# Access Compliance Report

## Public Rights-of-Way

Intersection ID: 47911	Main Street: ROOK_RD	Cross Street: RINGNECK_RD	Location: SW
ADA ID: CFBDBBE547D2	Ramp Type: PerpDiag	Initial Pass/Fail: Pass	Overall Compliance: No
Severity Score: 5.25			
Codes/Mitigation Info/Possible Solution		Field Measurements/Component Compliance

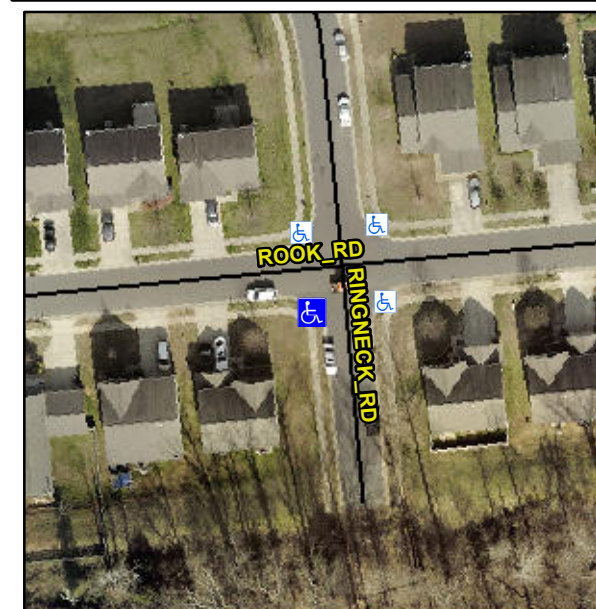
**R304.5.3, R305.2, R304.5.4**

Compliance	Description	Data	Compliance	Description	Data
N/A	Ramp Length (in)	47.0	Yes	Ramp Slope (%)	6.7
Yes	Ramp Width (in)	48.0	No	Ramp XSlope (%)	4.1
N/A	Flare Type LT	Sloped	N/A	Flare Type RT	N/A
N/A	Flare Slope LT (%)	5.2	Yes	Flare Slope RT (%)	0.5
N/A	Flare Traversable LT?	Yes	N/A	Flare Traversable RT?	Yes
Yes	Landing Length (in)	48.0	Yes	DWS Provided?	Yes
Yes	Landing Width (in)	48.0	Yes	DWS Contrast?	Yes
Yes	Landing Slope (%)	1.1	Yes	DWS Length (in)	24.0
No	Landing X Slope (%)	5.2	Yes	DWS Full Width?	Yes
N/A	Landing Curb? (Y/N)	No	No	DWS Offset (in)	3.5
N/A	Shared Landing?	No			
Yes	Gutter Ponding?	No	No	Gutter Slope (%)	6.2
Yes	Gutter Lip Ht (in)	0.0	No	Gutter X Slope (%)	2.8
N/A	Painted X Walk1?	No	N/A	Painted X Walk2?	No
	X Walk 1 Direction	To E		X Walk 2 Direction	To N
N/A	X Walk 1 Width (in)	N/A	N/A	X Walk 2 Width (in)	N/A
	X Walk 1 Slope (%)	2.9		X Walk 2 Slope (%)	1.8
	X Walk 1 X Slope (%)	2.8		X Walk 2 X Slope (%)	2.3

**Remove & Replace Curb Ramp With Two New Directional Ramps or Equivalent. Remove & Replace Gutter.**
